Brisbane Central Business District Bicycle User Group

The following comprises the Brisbane Central Business District Bicycle User Group (CBD BUG) submission on the draft reference design for the Breakfast Creek Green Bridge.

Figure 1 - BCC City Plan 2014 - Road Hierarchy

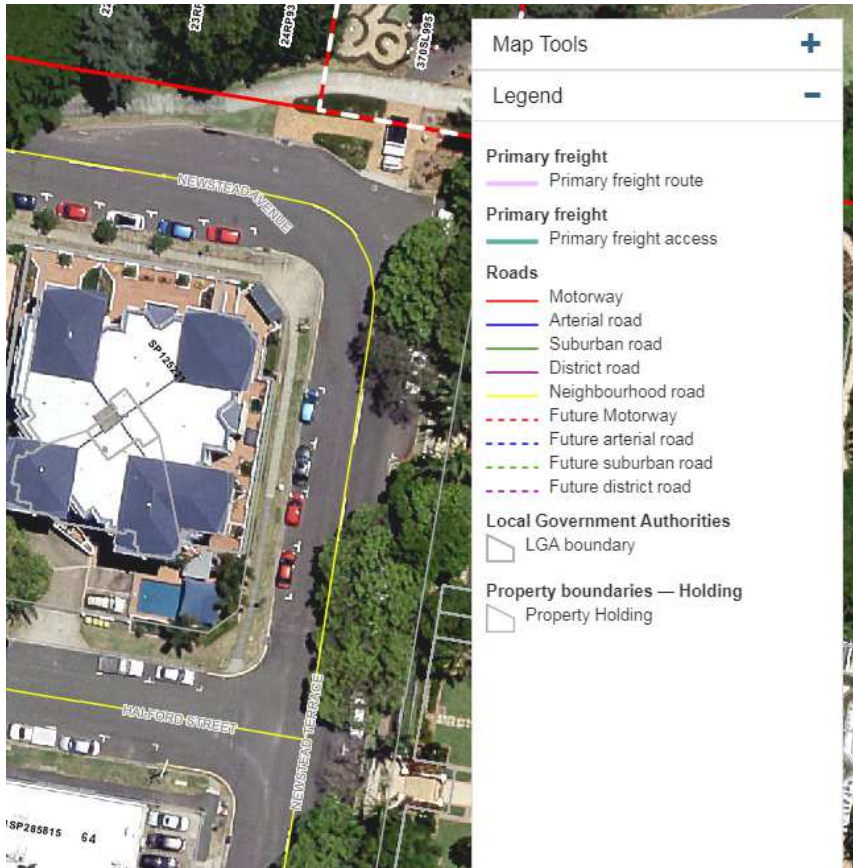
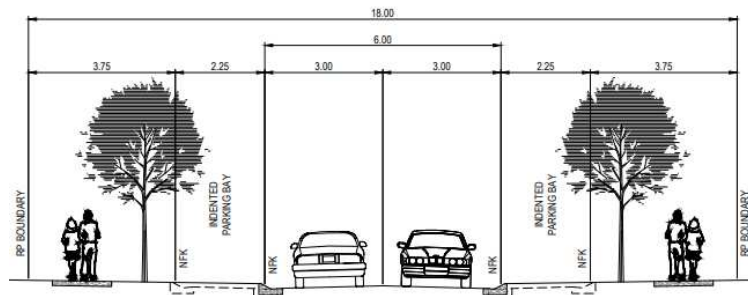
2. Both Newstead Ave and Newstead Tce are listed as "neighbourhood road" (Figure 1)
3. Newstead Ave as a shared path will not be a pleasant walking or cycling corridor without rearrangement of the road space. See Figures 3 & 4

Figure 2 - BCC Standard Drawings - Neighbourhood Road

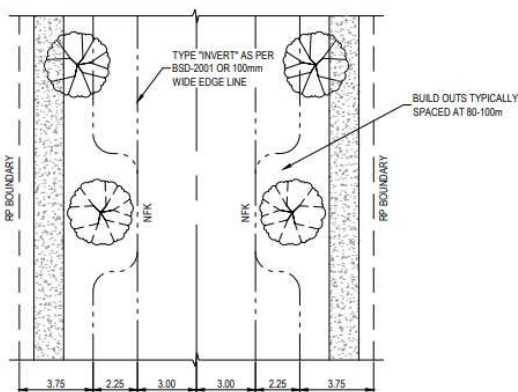
6. Proposed protected bikelanes are in accordance with the highly successful Sydney Cycleways (Figure 6)
7. Proposed general traffic lanes and parking spaces are in accordance with BCC standard drawings (Figure 2)

Figure 5 - Newstead Tce - Proposal - Concept Image

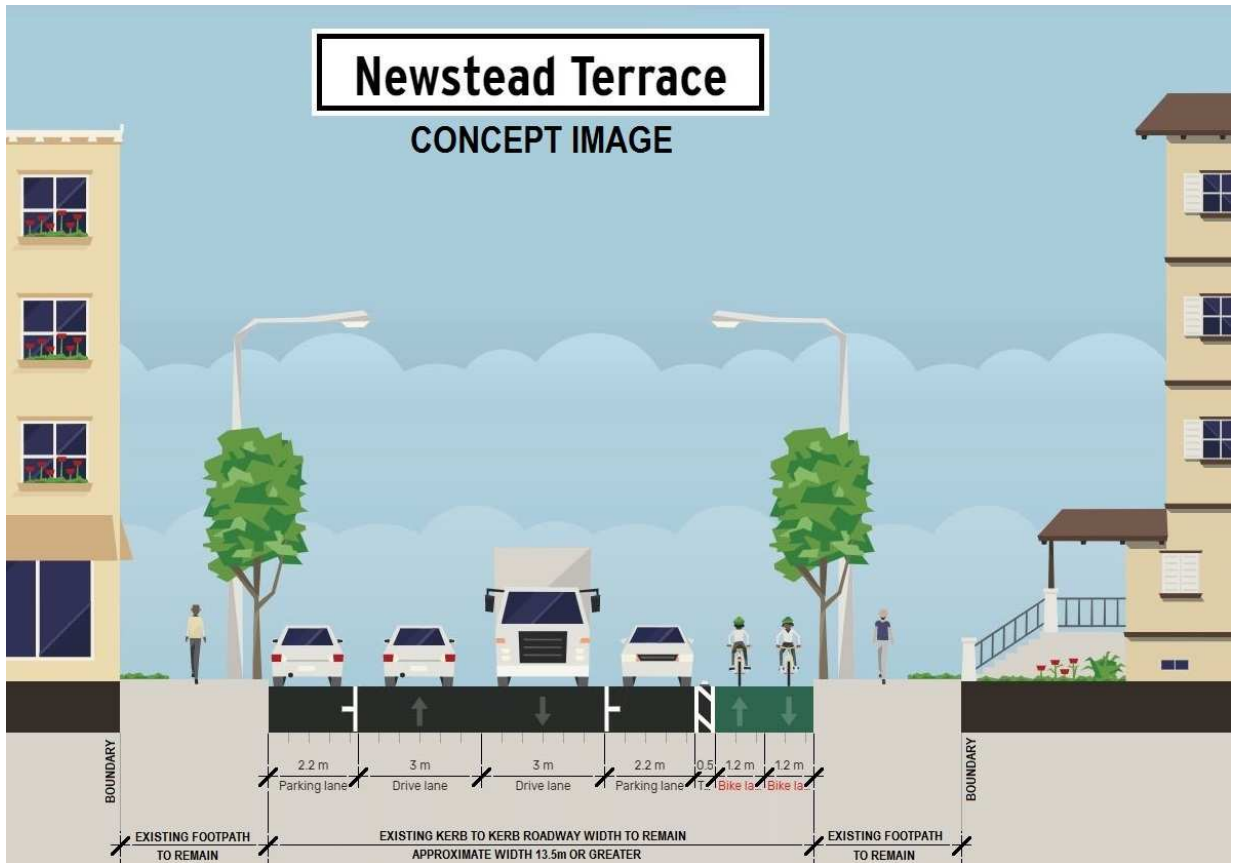
5. To provide a high capacity cycling corridor Newstead Tce could be reconfigured to have protected bikelanes. There is sufficient space for this as the existing road surface width from kerb to kerb is approximately 13.5m – 14m in width. See Figure 5

Figure 8 - Aerial View - Uncompleted bikeway

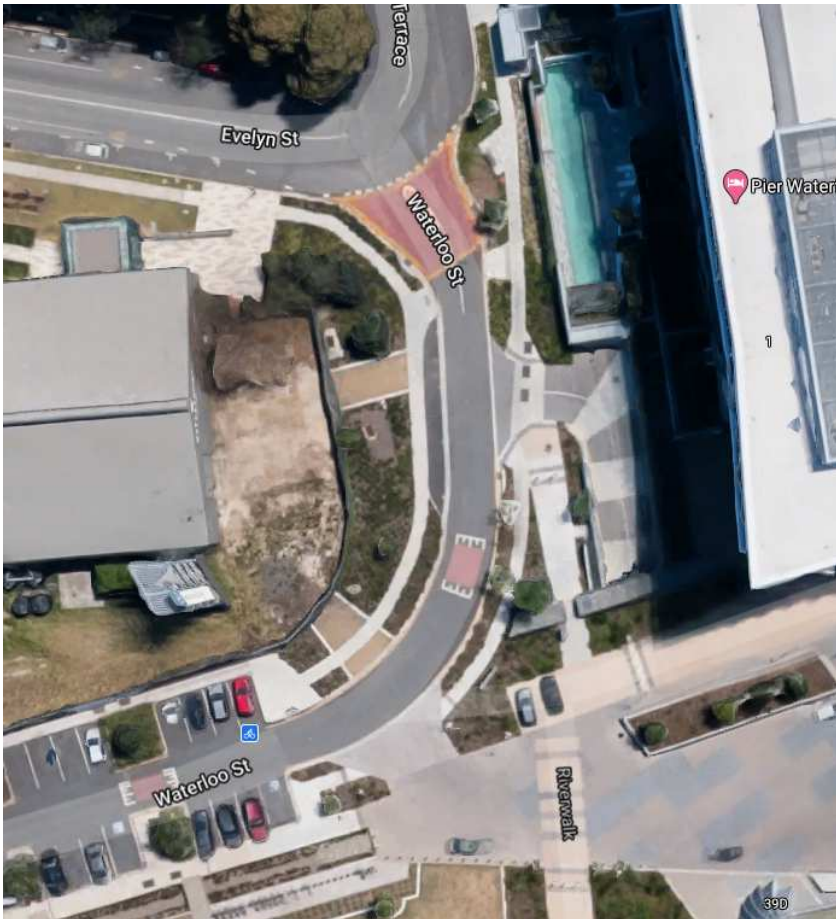
8. Instate the partially constructed bikeway into Waterfront Park. See Figure 7 and 8
